**SUNDRY NOTICES AND REPORTS ON WELLS**  
*Do not use this form for proposals to drill or to re-enter an abandoned well. Use Form 3160-3 (APD) for such proposals.*

**Burch Keely Unit 218**

**30-015-27650**

**Permanent Abandonment of Federal Wells**  
**Conditions of Approval (LPC Habitat)**

## Burch Keely Unit 218

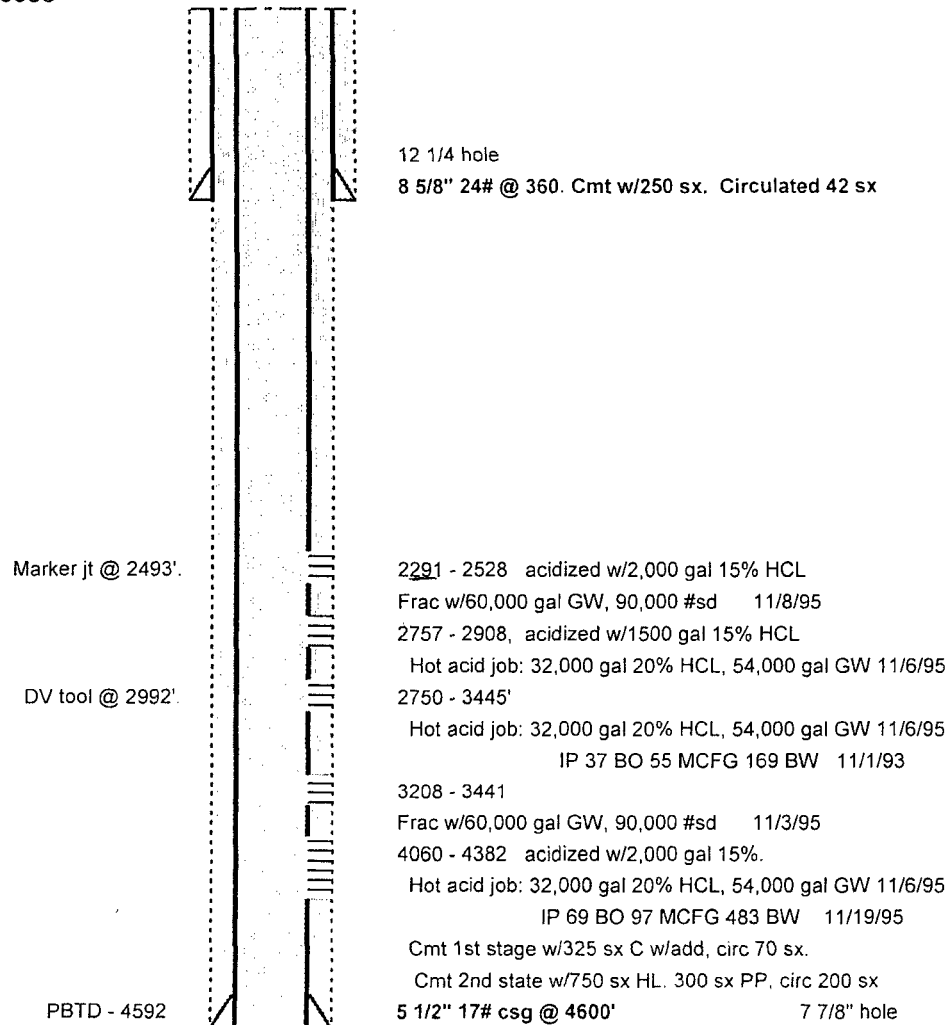
1. Set CIBP @ ~~2260'~~ <sup>2240</sup>. Circulate hole w/ mud laden fluid. Pressure test 5 1/2 csg. Spot 25 sx @ ~~2360-2160'~~ <sup>2240-2120</sup>.
2. Spot 25 sx @ 1711-1591. WOC & Tag.
3. Spot 25 sx @ ~~1400-1000'~~ <sup>1000-900</sup> WOC & Tag.
4. Spot 25 sx @ 410-310'. WOC & Tag.
5. Spot 25 sx @ 100-Surface.
6. Cut off well head, verify cmt behind annulus, weld on Dry Hole Marker.

3. Spot 25 sx @ 100-1000'. WOC & Tag.

1. Set CIBP @ 2240'. Circulate hole w/ mud laden fluid. Pressure test 5 1/2 csg.  
Spot 25 sx @ 2240-2120'  
Marker jt @ 2493'
